Planning Approval Consistency Assessment Form

Assessment name:	Change in location of Airport Portal Dive Site
Prepared by:	[REDACTED]
Prepared for:	Sydney Metro, SBT and SSTOM contractors, Western Sydney Airport (WSA)
Assessment number:	SM005
Status:	Final
Version:	0.3
Planning approval:	EPBC 2019/8541 and Western Sydney Airport: Airport Plan (as varied September 2021)
Date required:	April 2022
iCentral number:	SM-22-00178799
© Sydney Metro 2020

Description of proposed works (change in location of Airport Portal Dive Site and services building)

Figure 3: Revised operational Airport Portal Dive Site location and alignment.

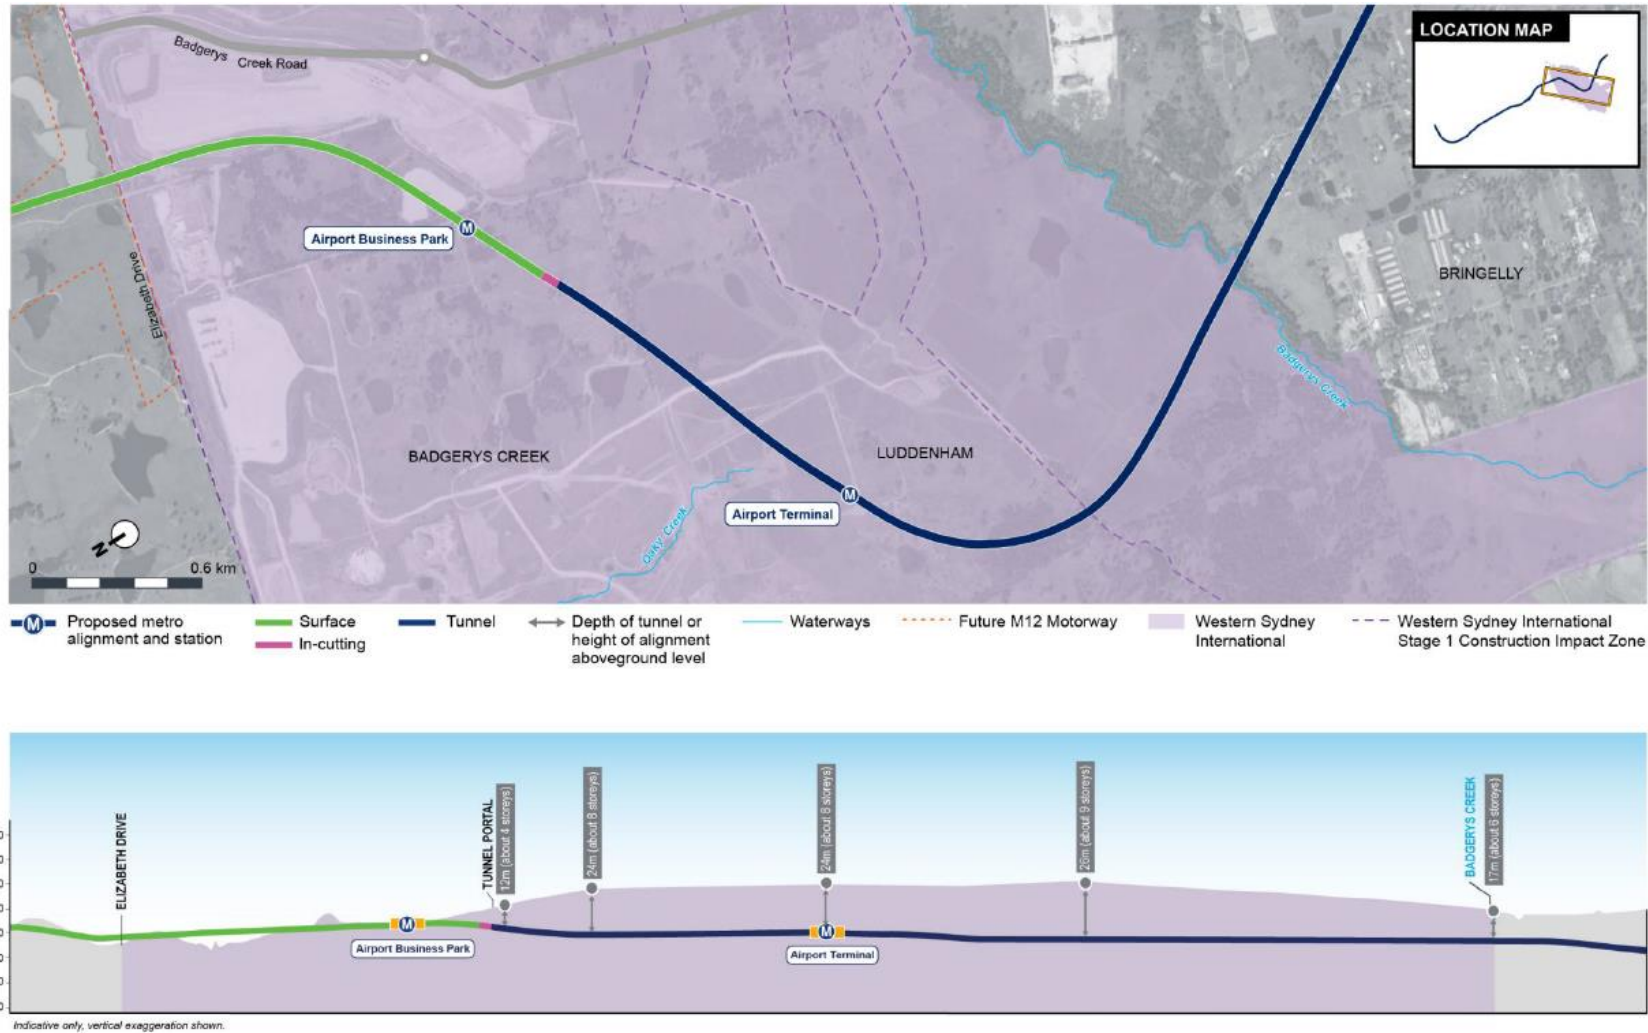
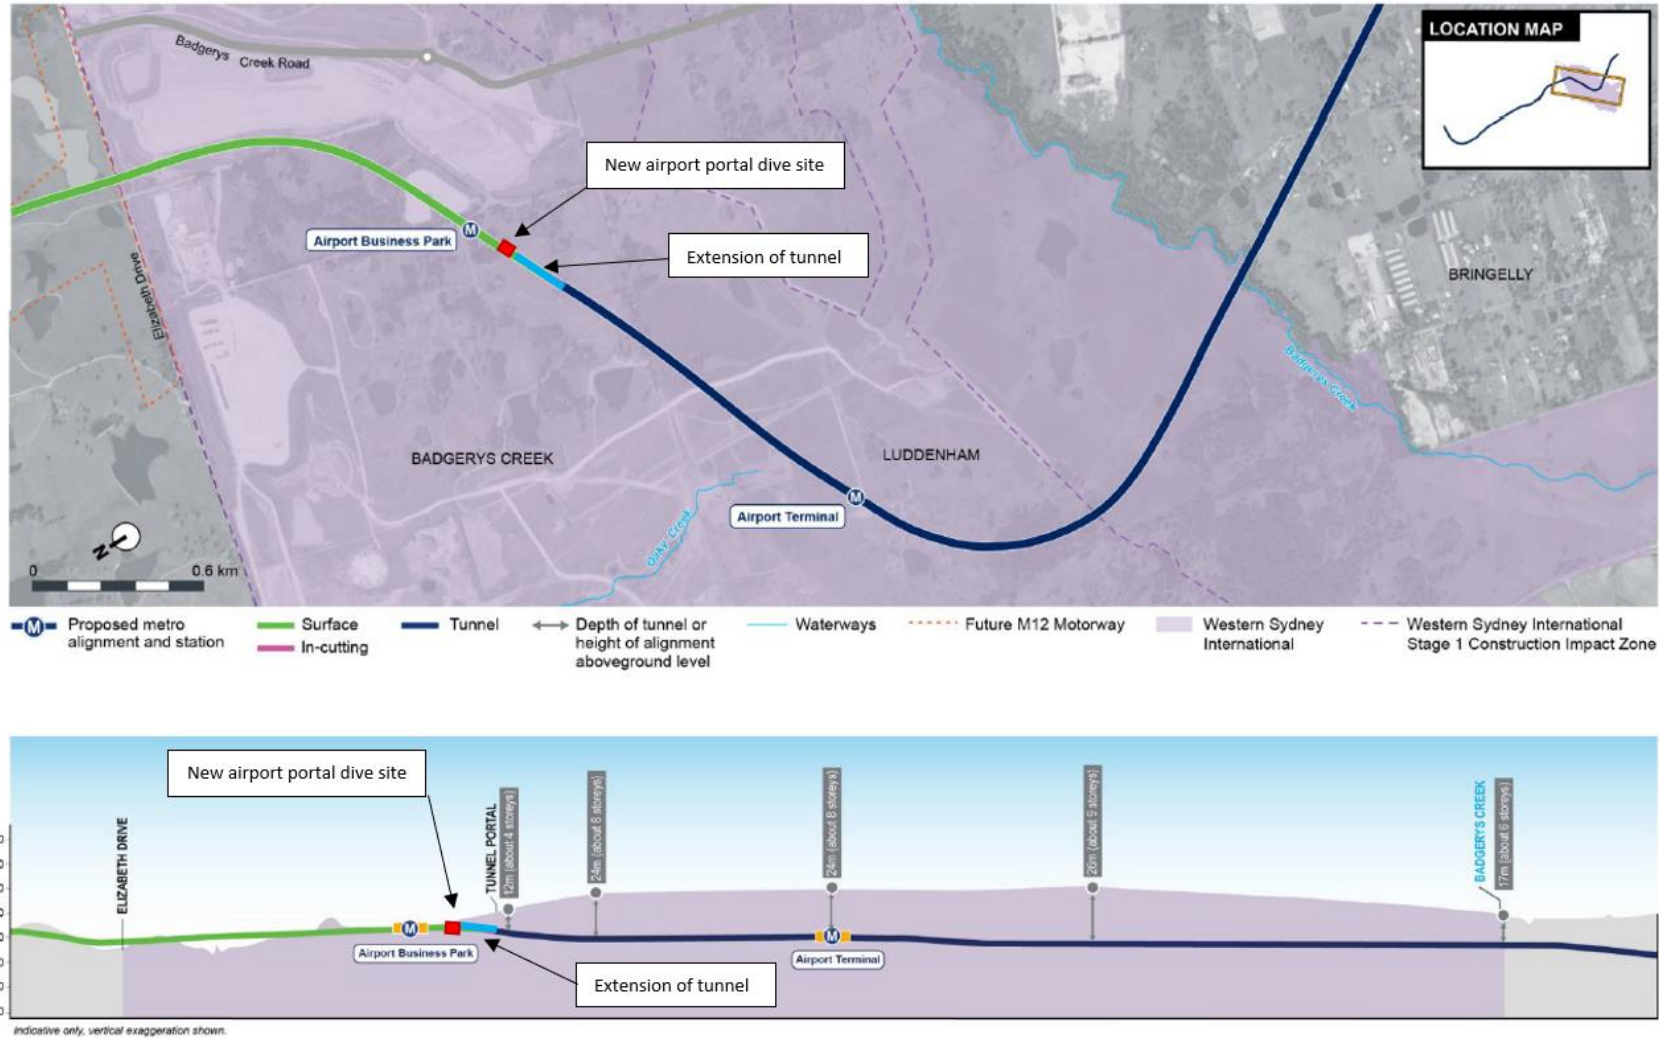
The southern headwall of the APDS is proposed to move approximately 200 metres to the north-east within the approved alignment of the rail corridor. The revised location is shown in Figure 3 of Appendix A. The change would result in an approximate 270 metre reduction in length in the open cut alignment and an approximate 200 metre increase in the length of the bored southern tunnel.

The services building on top of the APDS would also be relocated approximately 200 metres north-east, allowing the return of unused land to WSA. The services building provided at the tunnel portal will increase in length to about 130 metres at ground level. The proposed tunnel portal at its new location is shallower so the length of the building would increase to accommodate the required functional rooms. Due to the increase in building footprint, inclusion of photovoltaic (PV) solar panels on the building roof is being considered.

The proposed works would continue to be located within the boundary of the Western Sydney Airport site (Lot 100 DP1263171) on land owned by the Commonwealth and currently leased to Western Sydney Airport. The location of the proposed works is shown in Appendix A and is within land leased by Sydney Metro from Western Sydney Airport. Figure 1 shows the approved construction site, Figure 2 shows the approved location of the APDS and rail alignment and Figure 3 shows the proposed change in location.
